Subject: **HIGH FLUTTER WHEN USING "EXT SRC" INPUT**

Model: **APR-5001/5002/5003**

Serial No: **20,201 AND HIGHER (APR-5001)**
20,201 AND HIGHER (APR-5002)
20,401 AND HIGHER (APR-5003)

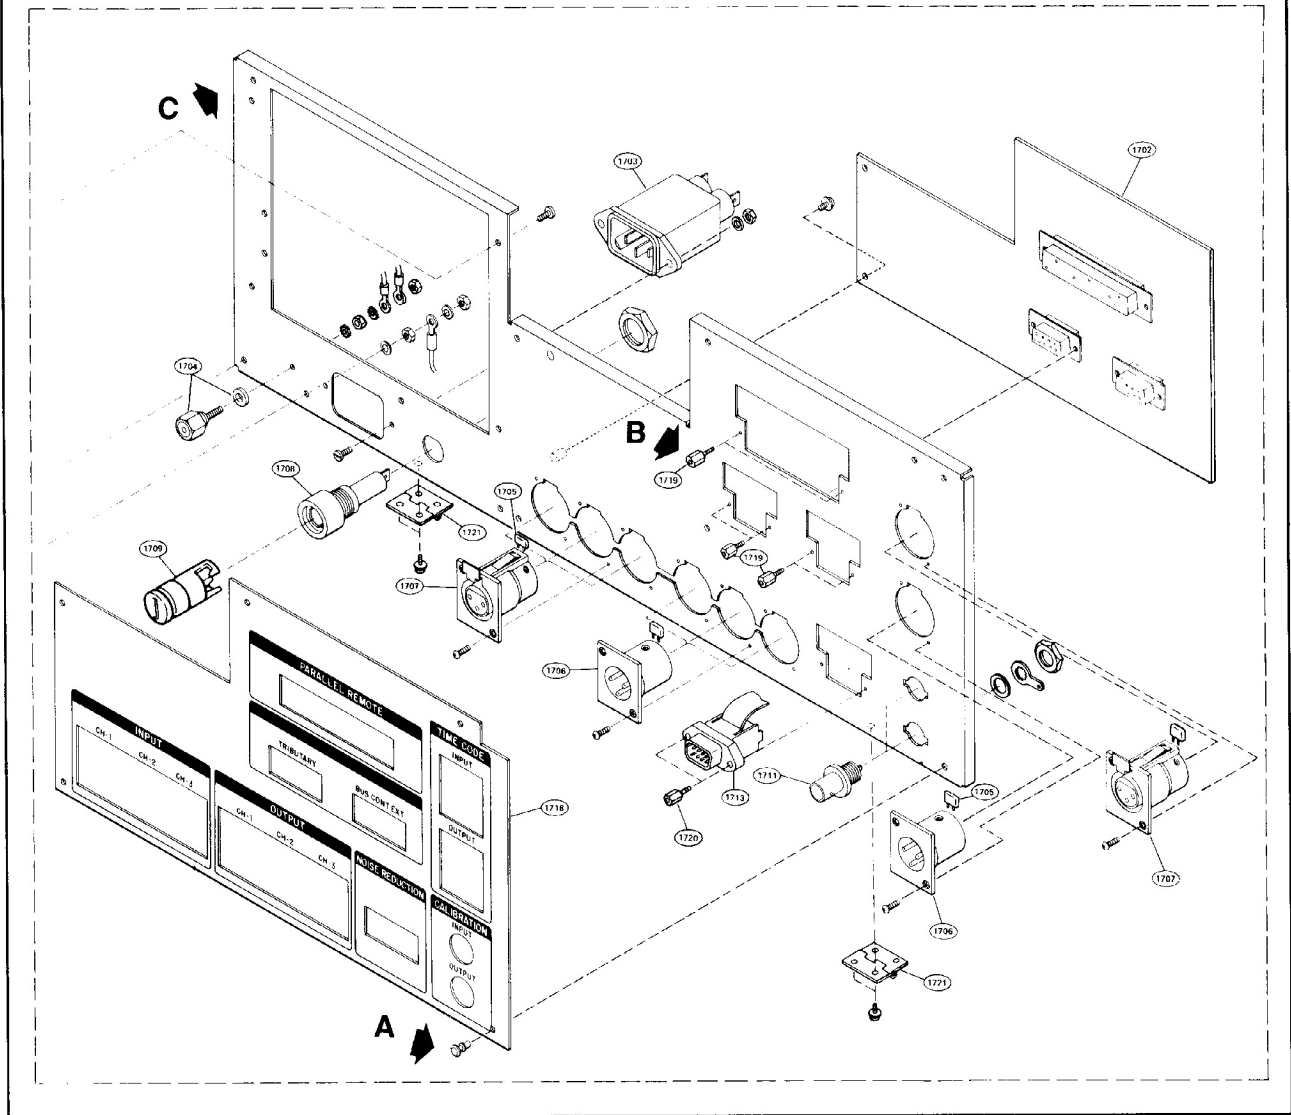
3. Open lower rear panel by removing screws (2) located in upper left- and right-hand corners (C). (See Figure 1.)
4. Remove CNX board by first removing screws (2) holding board in place (A). (See Figure 2.)
5. Push connectors out through cutouts so CNX Board can clear lip of outer panel when being lifted out.
6. If CNX board is numbered T-9412-316-1, it will have a 5-pin resistor network (RN1) instead of discrete resistors at R80 and R81. If so, remove IC7 (HCPL-2730) and replace with HCPL-2531 (T-9413-636-1). No resistor changes are needed.
7. If CNX board is numbered T-9412-316-2 through T-9412-316-4, or 1-619-162-11, proceed with steps a and b.
 - a. Remove IC7 (HCPL-2730) and replace with HCPL-2531 (T9413-636-1).
 - b. Remove R80 and R81 (470Ω) and replace with 4.7kΩ resistors.
8. Reinstall CNX Board by repeating steps 1 and 2 in reverse order.
